NUMBER: 23-037-17 REV. A

Odor Coming from Engine Compartment

This bulletin involves replacing the cowl seal gasket and sealing off the two vent holes in the hood.

2017 (GA) Alfa Romeo Giulia

Fig. 1
Underhood View

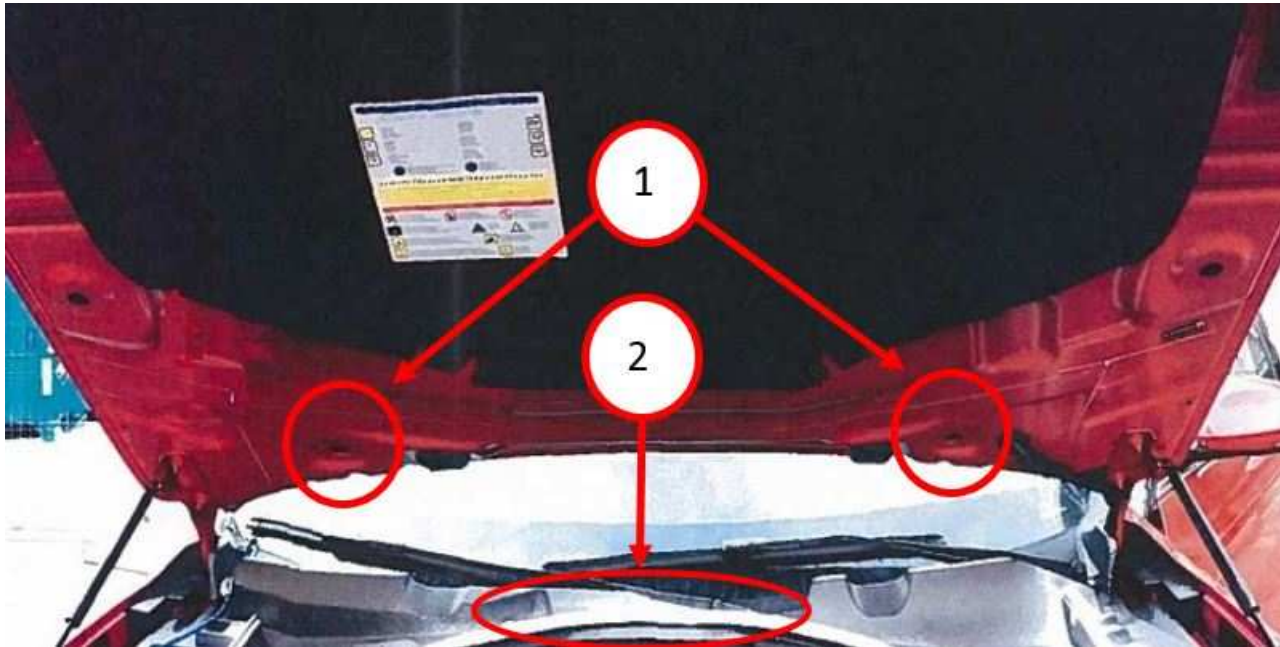
1. Open hood and locate the cowl seal gasket (Fig. 1) . Replace the gasket with the revised part listed in Parts Required. Verify seal makes contact to hood.

Fig. 2
Hood Vent Holes

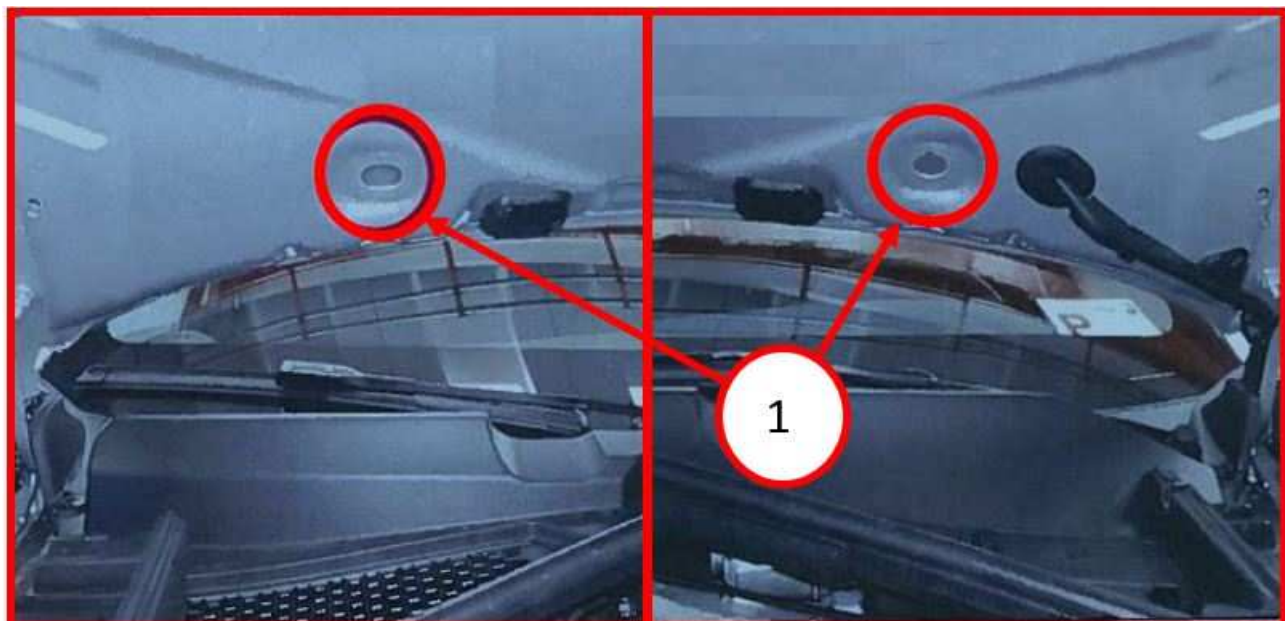
2. Clean area around vent holes (Fig. 2) with isopropyl alcohol to allow insulating tape to stick to surface.

3. Apply the insulating tape to cover vent holes.
